# Technical Service Information

## FORD 5R55W

### NO 2nd OR 5th

Figure 1

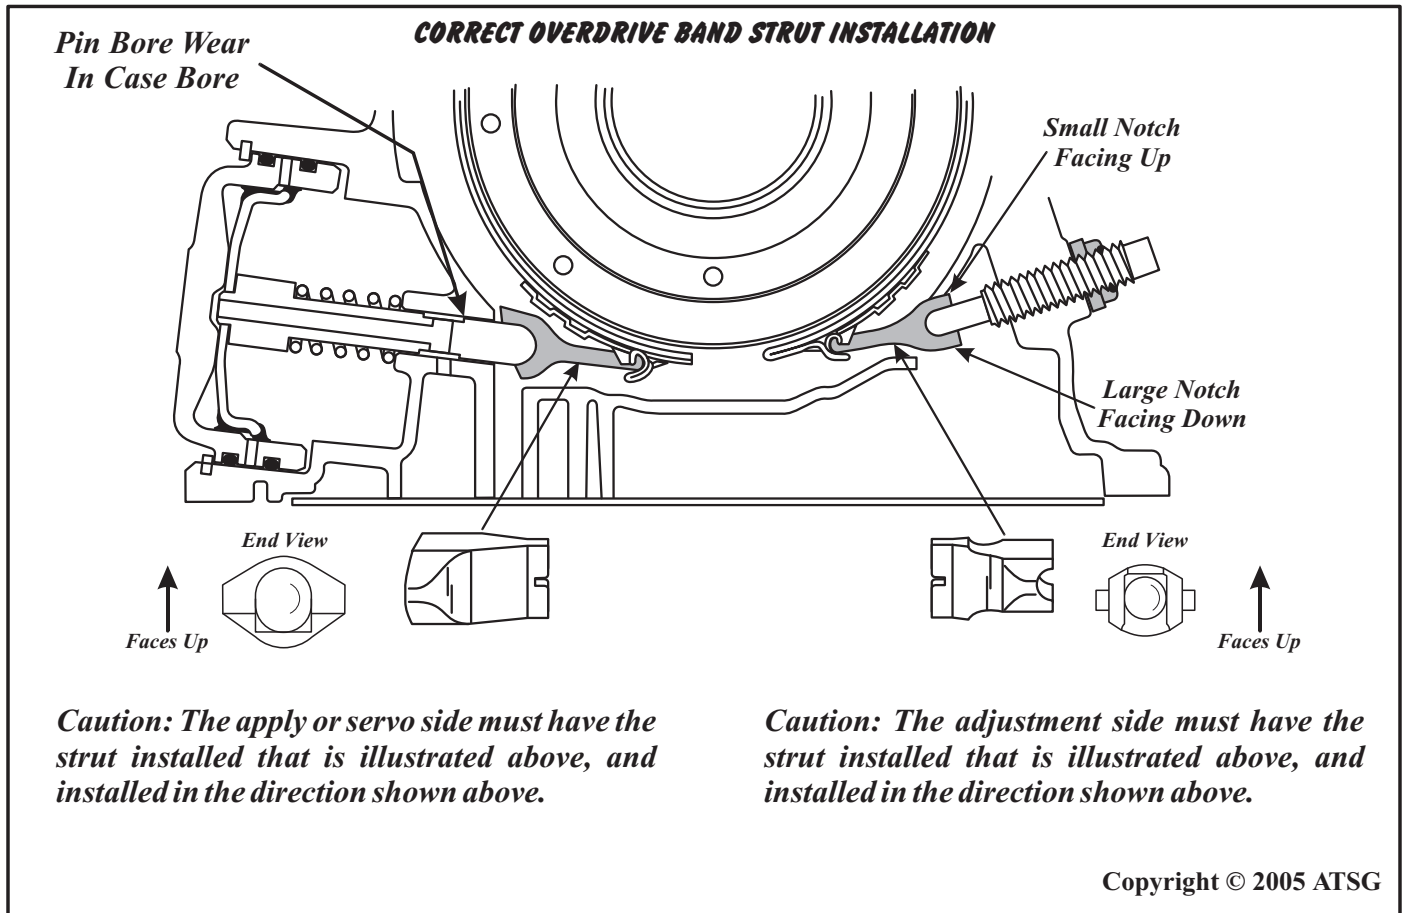
**COMPLAINT:** Vehicles equipped with the 5R55W transmission may exhibit a no 2nd or no 5th gear condition, before or after overhaul.

**CAUSE:** The cause may be, that the band struts were installed upside down, or the servo bore is worn. The Overdrive servo is fed thru the center of the apply pin. Wear in the case, where the servo pin rides, may cause a pressure loss, creating the band failure. See Figure 1.

**CORRECTION:** To correct this condition, refer to Figure 1 for the correct assembly of the band struts. Replace the case or re-sleeve the case where the pin rides and install a bushing for a new sealing surface. *Northland transmission Inc. has a Re-boring kit available to repair the case bore, with a bushing, to fix the leak.*  
*Phone: 715-458-2617*
